Subject: VIRGIL C. SUMMER NUCLEAR STATION
DOCKET NO. 50/395
OPERATING LICENSE NO. NPF-12
RESPONSE TO INITIAL QUESTIONS DATED
OCTOBER 23, 2000
MSP 00-0244

Responses to NRC Questions on

A loop hot leg crack

Dated 10/23/2000

FIGURE 2
VC SUMMER NUCLEAR STATION
"A" LOOP HOT LEG NOZZLE
EXISTING WELD DESIGN

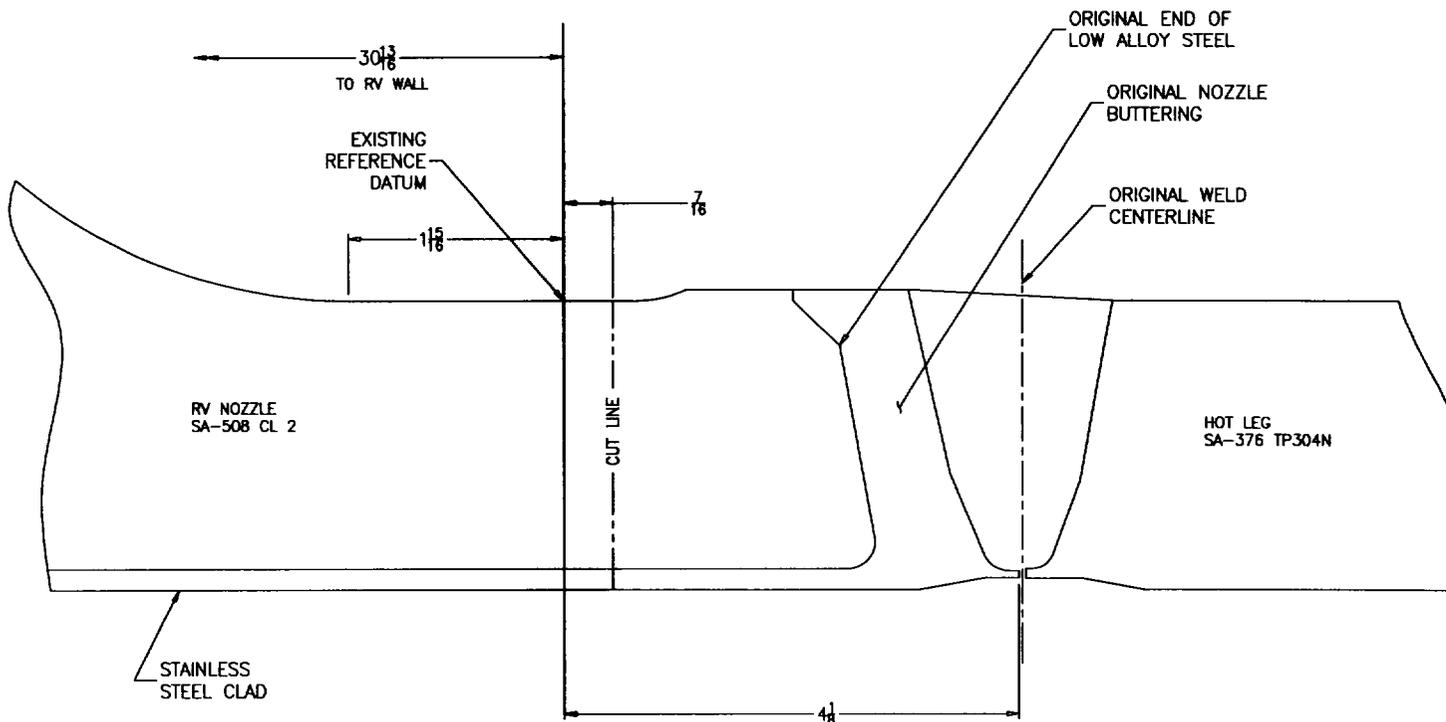
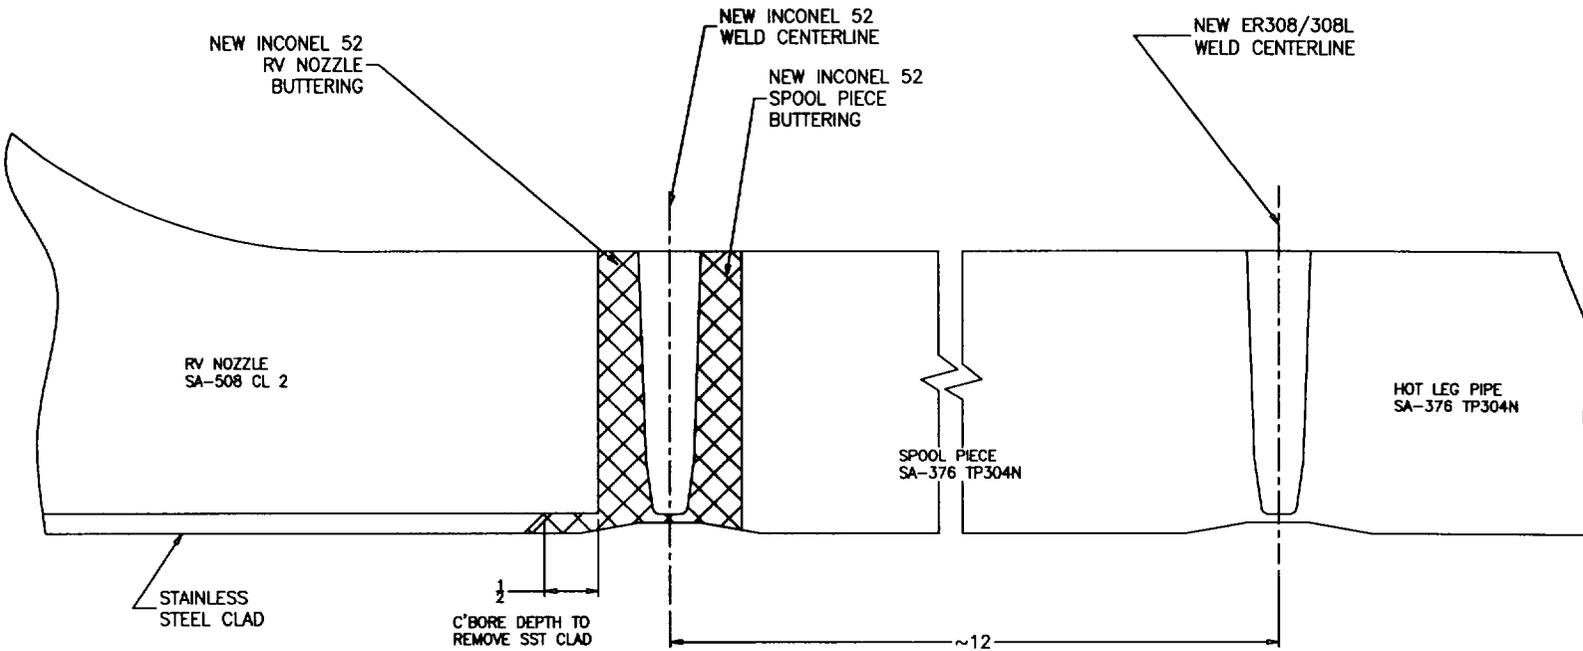
9. Describe in detail the schedule and scope for performing repairs for the subject weld.

The pre-existing field configuration is illustrated in Figure 2. The repair plan included the removal of the defective weld along with all of the nozzle butter and approximately 8 inches of the pipe. A stainless steel pipe spool piece was welded back in to restore the integrity of the RCS (Figure 3).

The nozzle was built up with Alloy 52 to prepare for the nozzle-to-spool weld. The stainless steel cladding on the inside of the nozzle was removed for a distance of 1/2 inch from the nozzle end. The cladding was replaced with Alloy 52. Both activities were completed using machine gas tungsten arc welding (GTAW) and using the temper bead process.

The nozzle end of the replacement spool piece was buttered using the GTAW process and Alloy 52 filler material. This activity eliminated the need to perform a dissimilar metal weld in the field during installation.

After the weld build up was complete, a groove was machined on the inside diameter of the spool piece, centered on the heat-affected zone under the buildup. An Alloy 52 weld overlay of this groove was performed as an engineered improvement to enhance the corrosion resistance of the spool piece.

The spool piece was machined on both ends to the narrow groove weld design, inspected per Code requirements and installed into the piping. This installation involved two narrow groove closing weld operations from the outside diameter. The nozzle-to-spool piece weld employed machine GTAW and Alloy 52 filler materials. The pipe-to spool piece weld employed machine GTAW and SFA 5.9 ER 308/308L (stainless steel) filler materials. ASME Code, Section III, qualified welding procedures were utilized, and radiography of the stainless steel weld was found to be acceptable.
